**Addendum No. 2
January 20, 2023**

Project: Baltic High School Addition
Baltic, South Dakota
Arch Project No. 2957

Architect: Architecture Incorporated

FIRST FLOOR DEMOLITION PLAN - AREA A
SCALE: 1/8" = 1'-0"

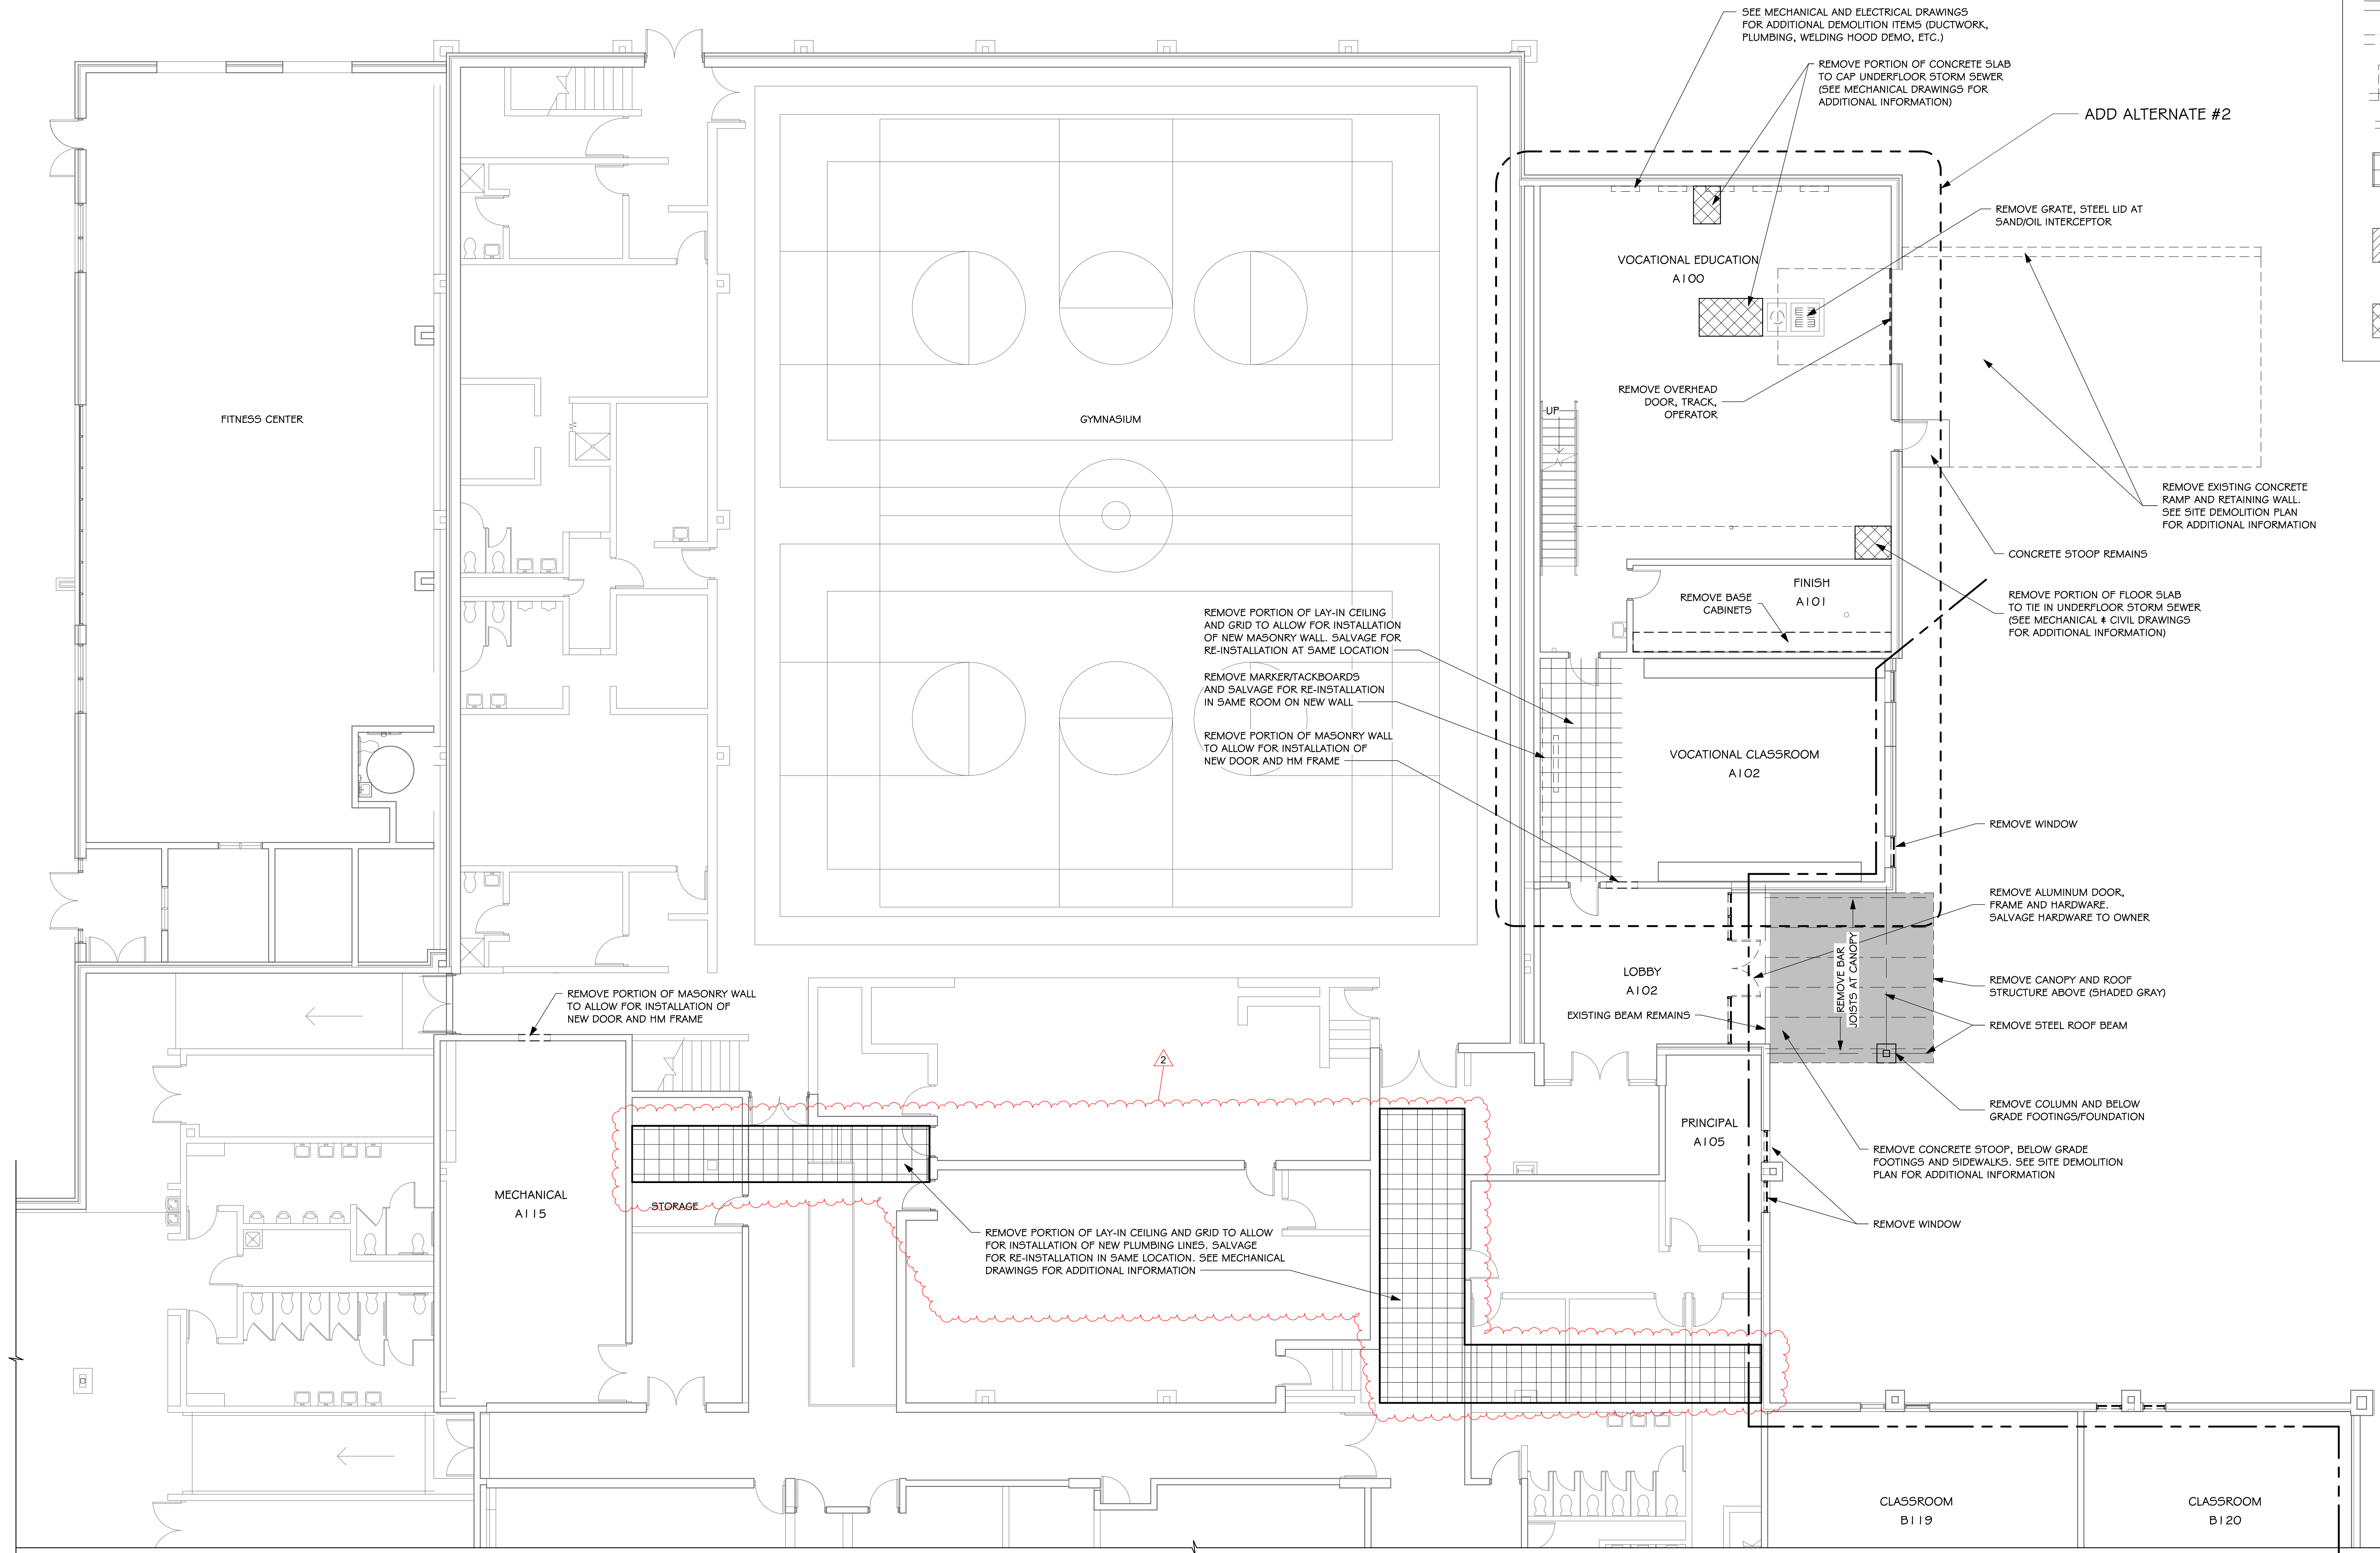
- a) CLARIFICATION: The Contractor shall remove & replace existing lay-in ceilings and grid to allow for installation of mechanical piping; see mechanical drawings. Salvage tile and grid for re-installation.
 - i) Reference revised drawing Sheet 4.00 attached to the end of this addendum for additional information.

FIRST FLOOR - DEMOLITION PLAN - AREA B

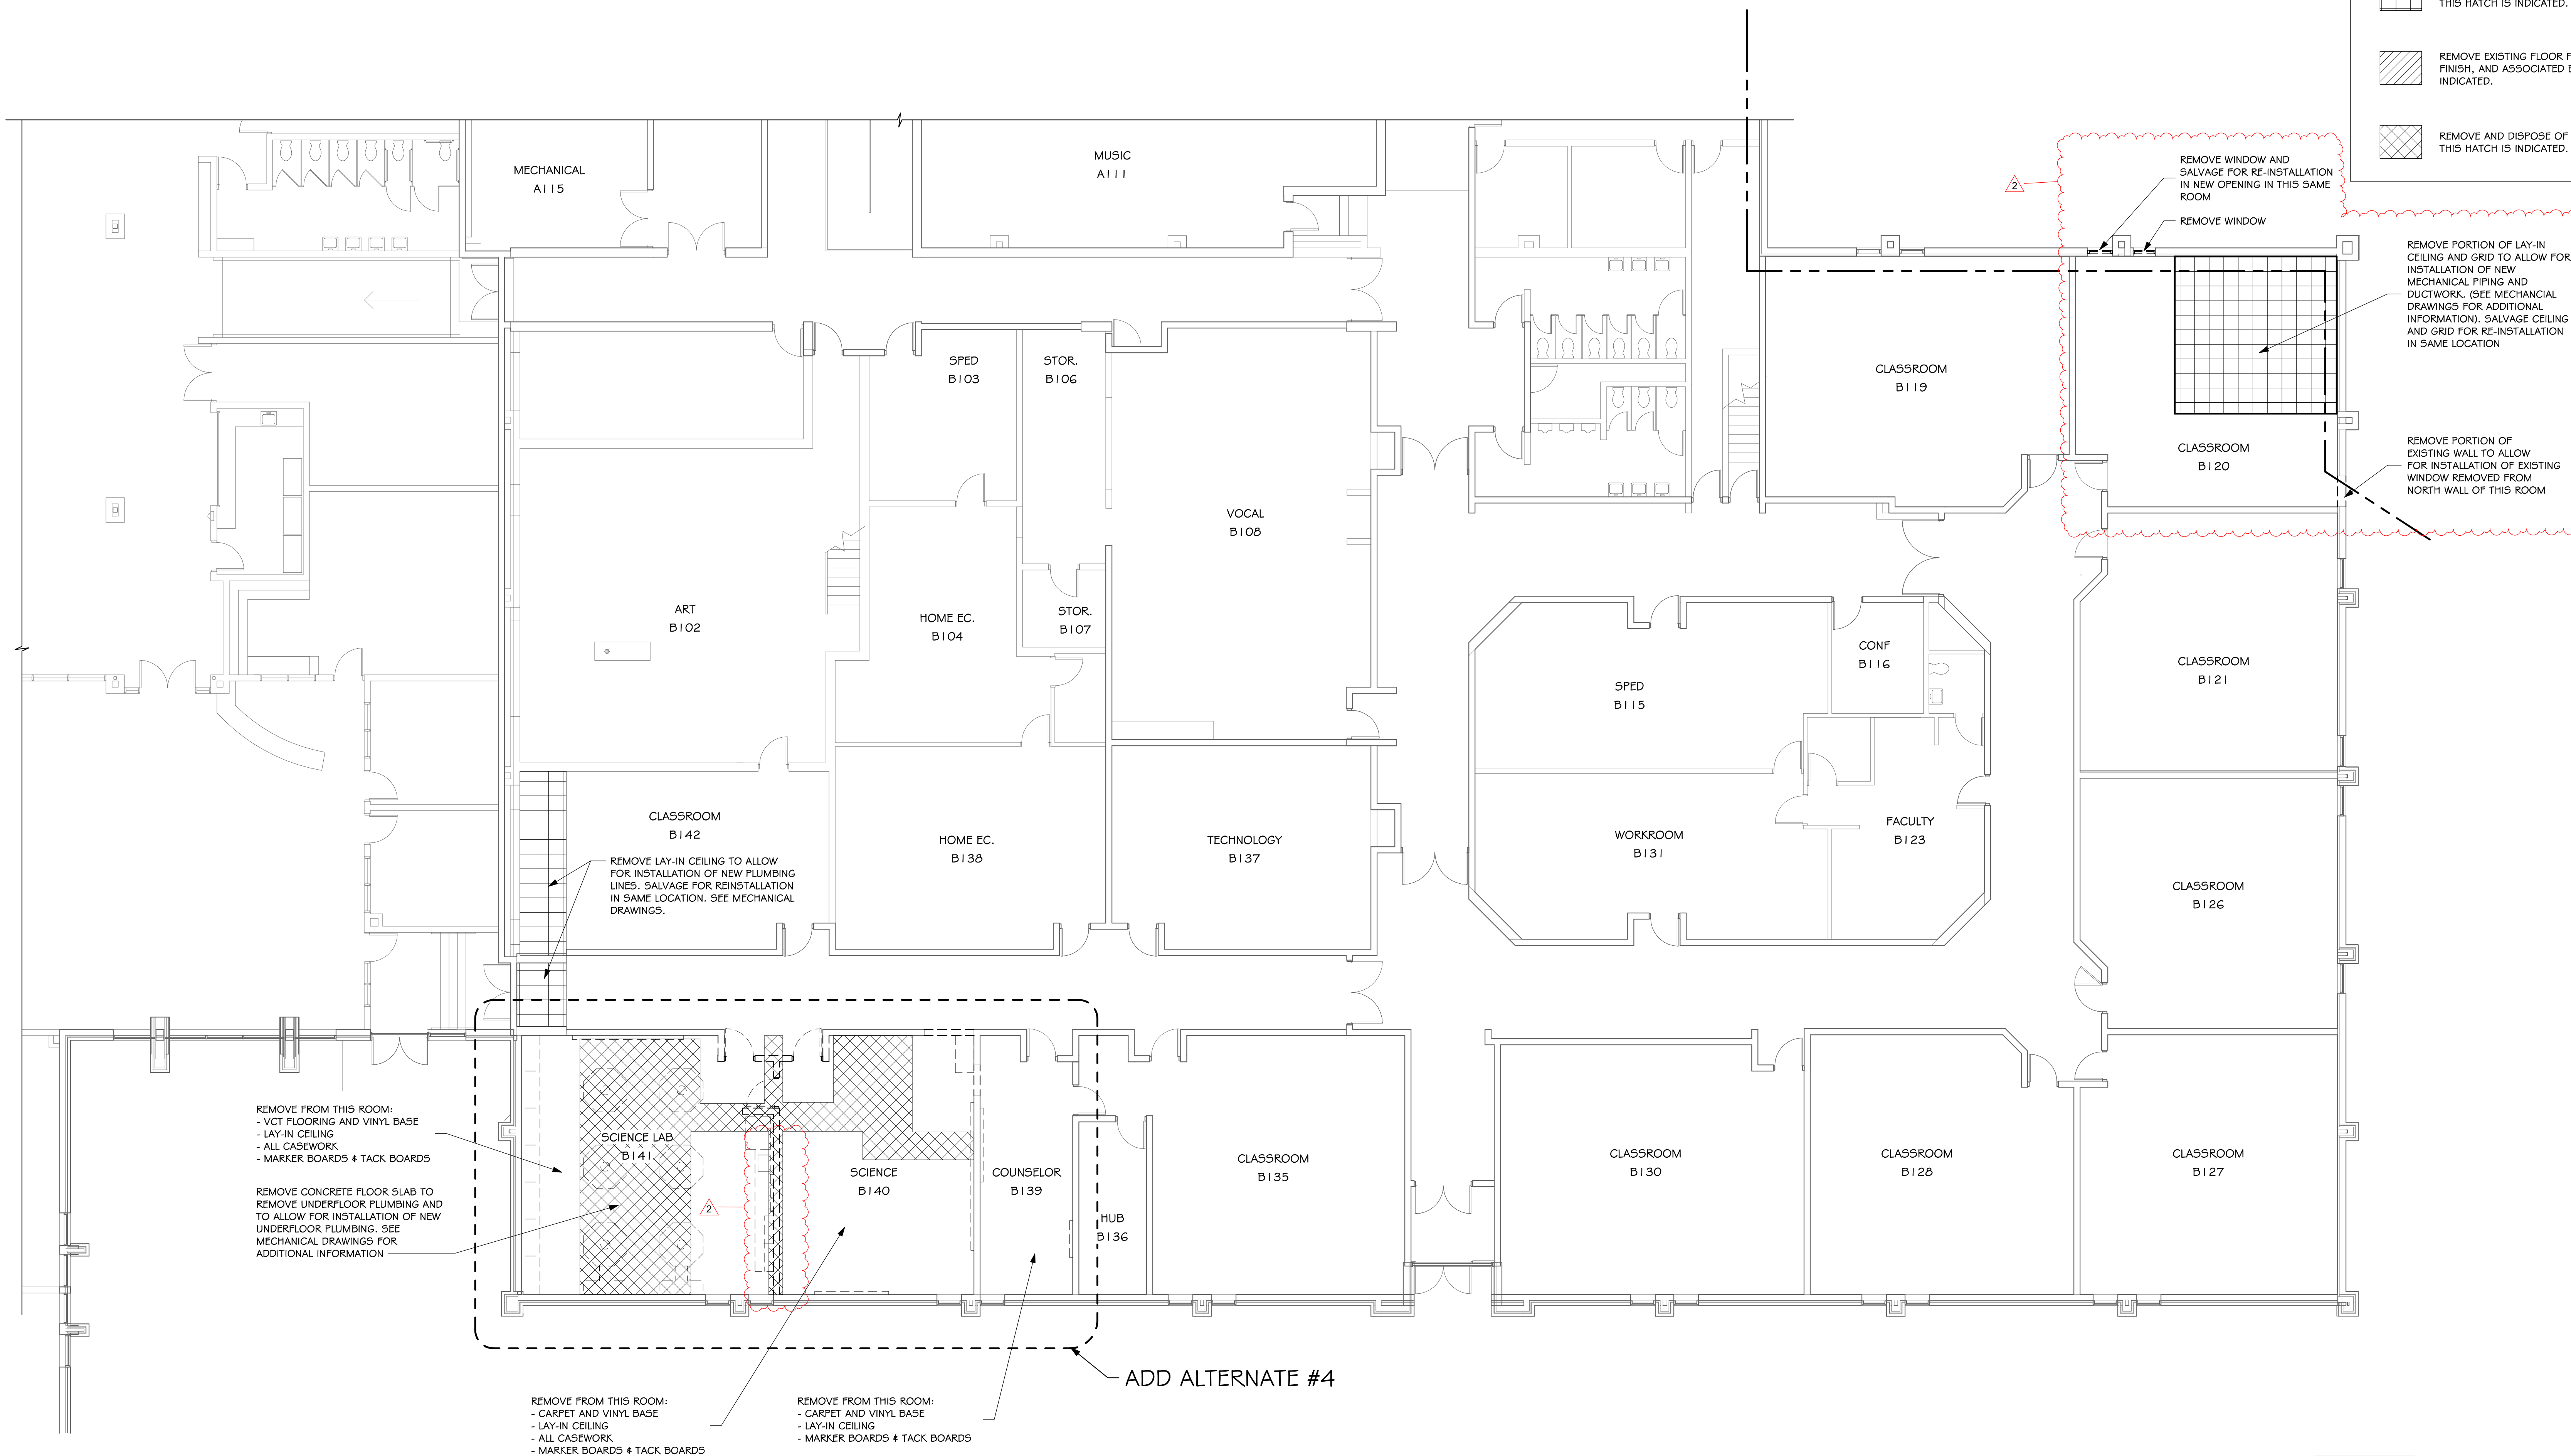
- iii) Reference revised drawing Sheet 4.01 attached to the end of this addendum for additional information.
- b) CLARIFICATION: Add Alternate #4 – Science Room Remodel:

FIRST FLOOR PLAN - AREA F

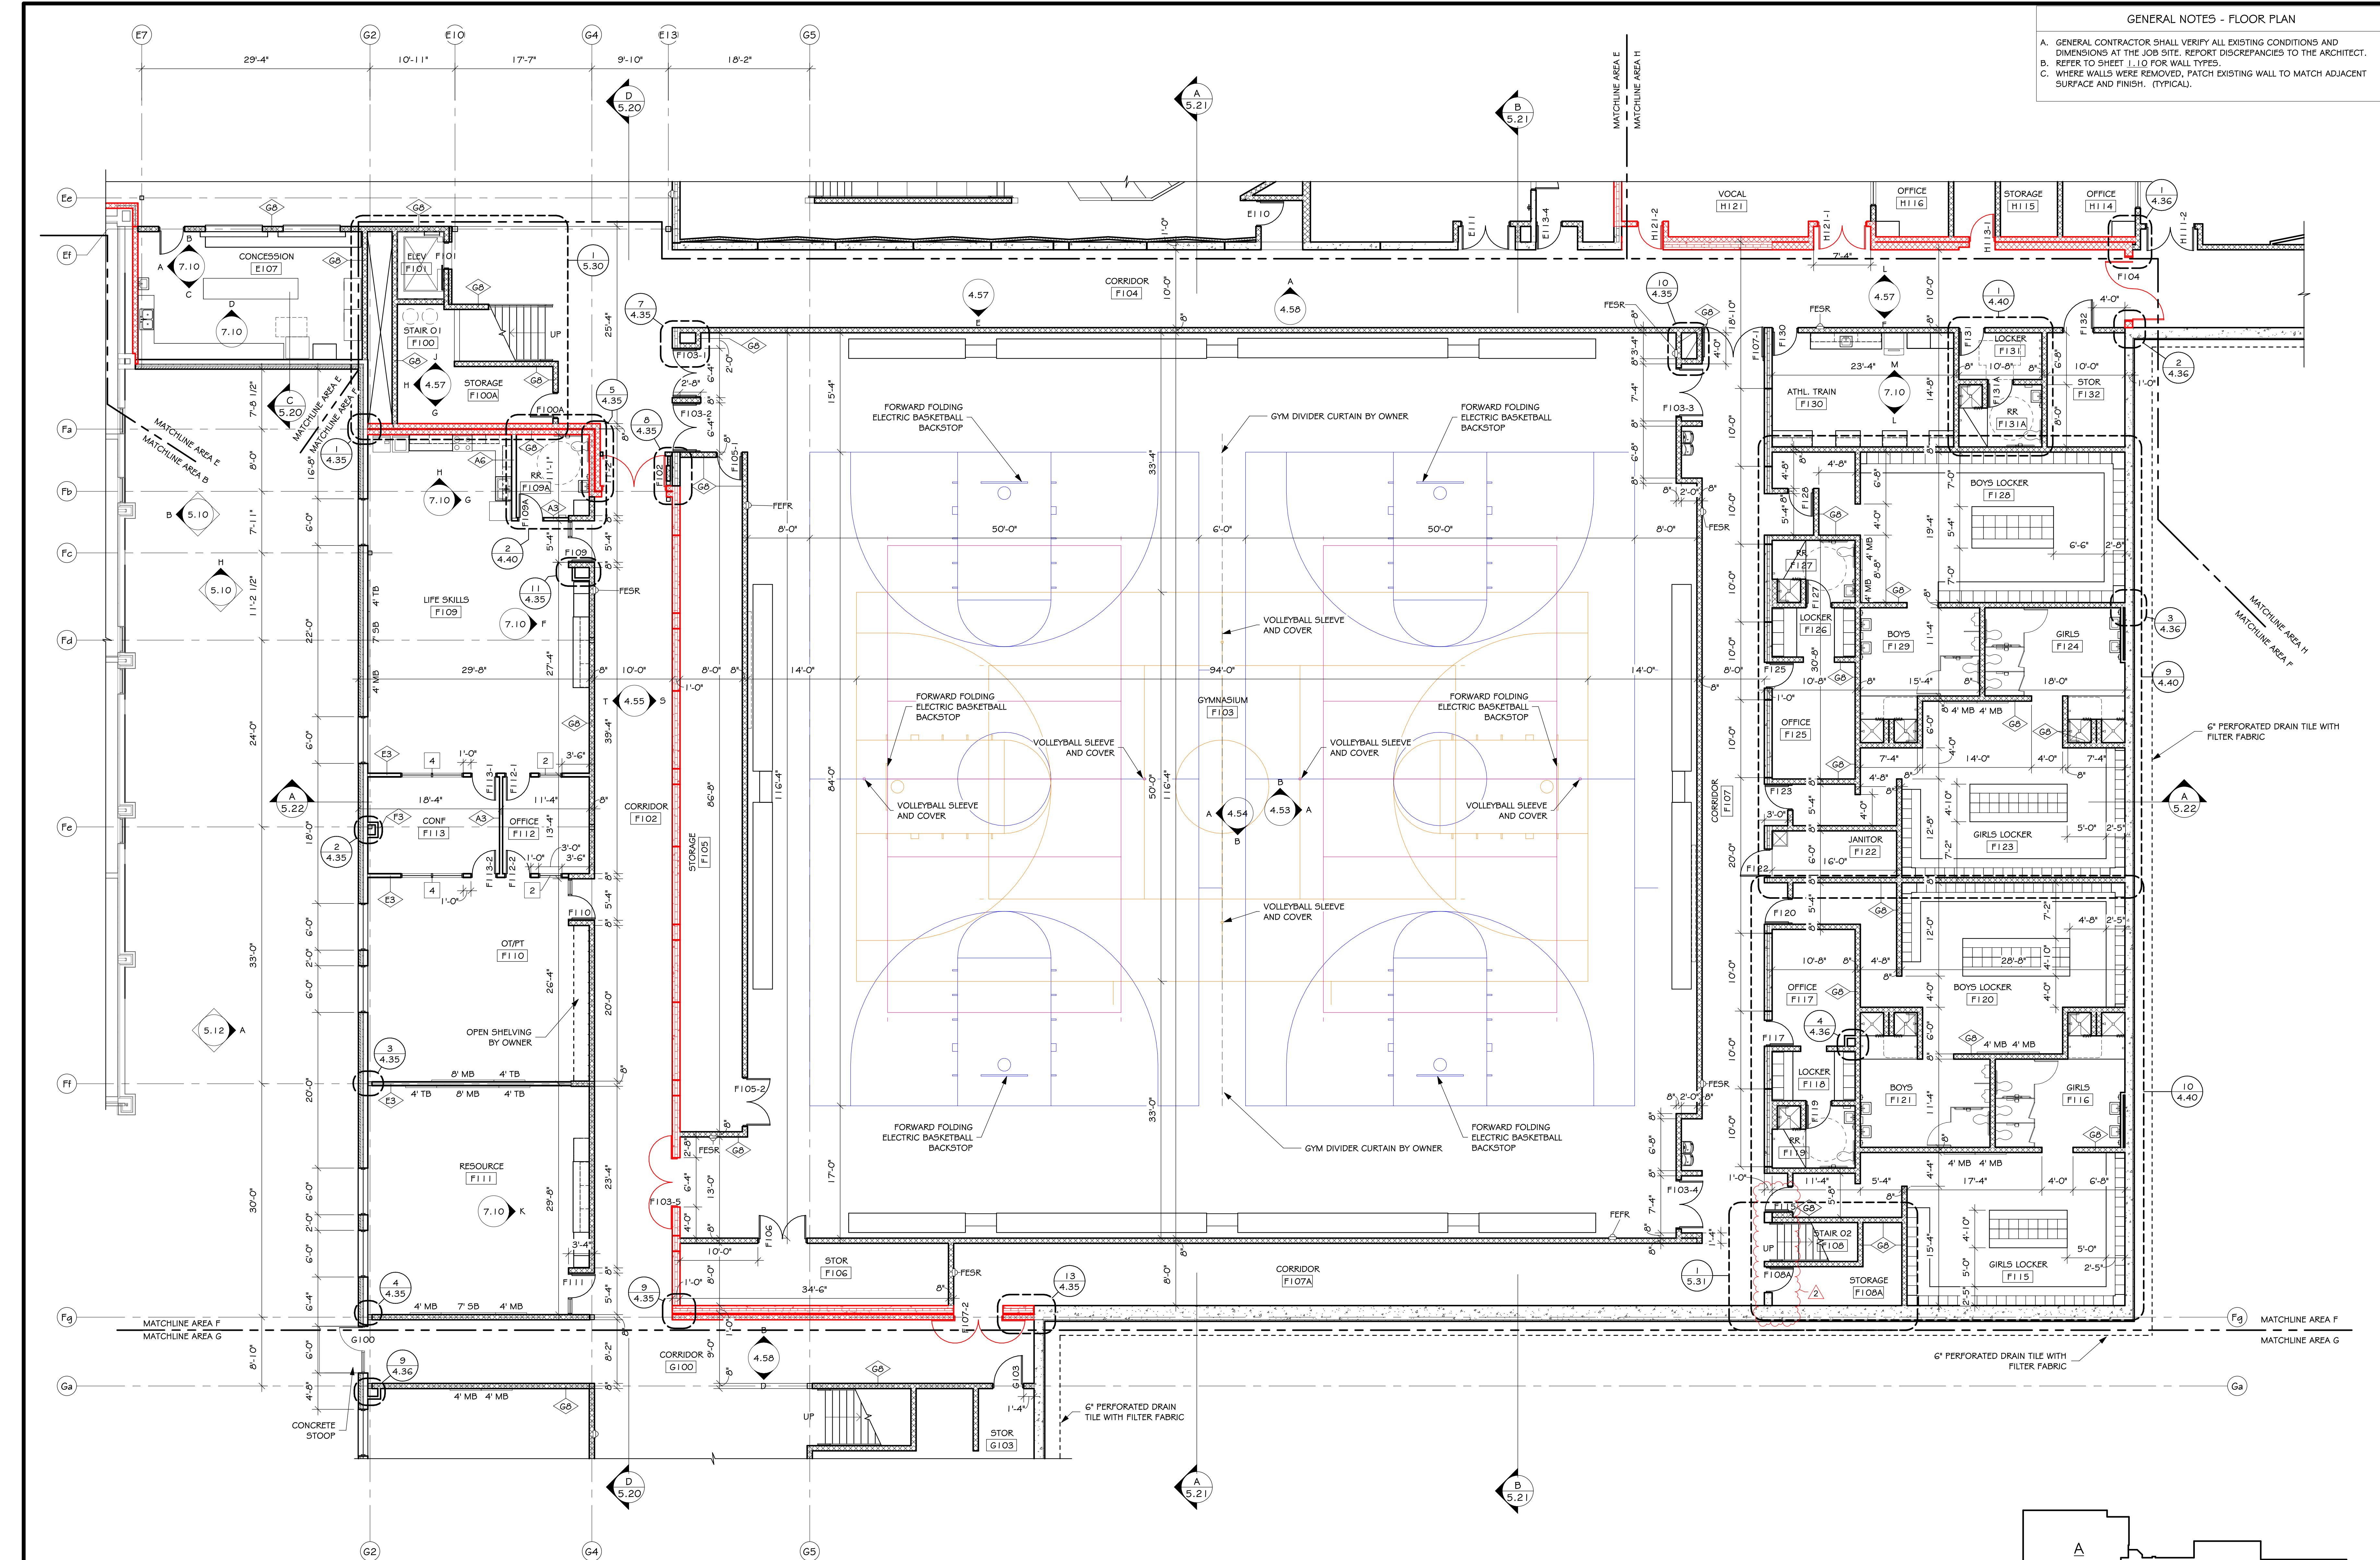
- a) Relocate door F108A as indicated per *revised* drawing Sheet 4.10-1F which is attached to the end of this addendum; shift door north; change door to left hand swing as shown.
- b) Provide a 12” x 16” (solid) precast column adjacent to door F115 as indicated per *revised* drawing Sheet 4.10-1F which is attached to the end of this addendum. Reference structural drawings for additional information.
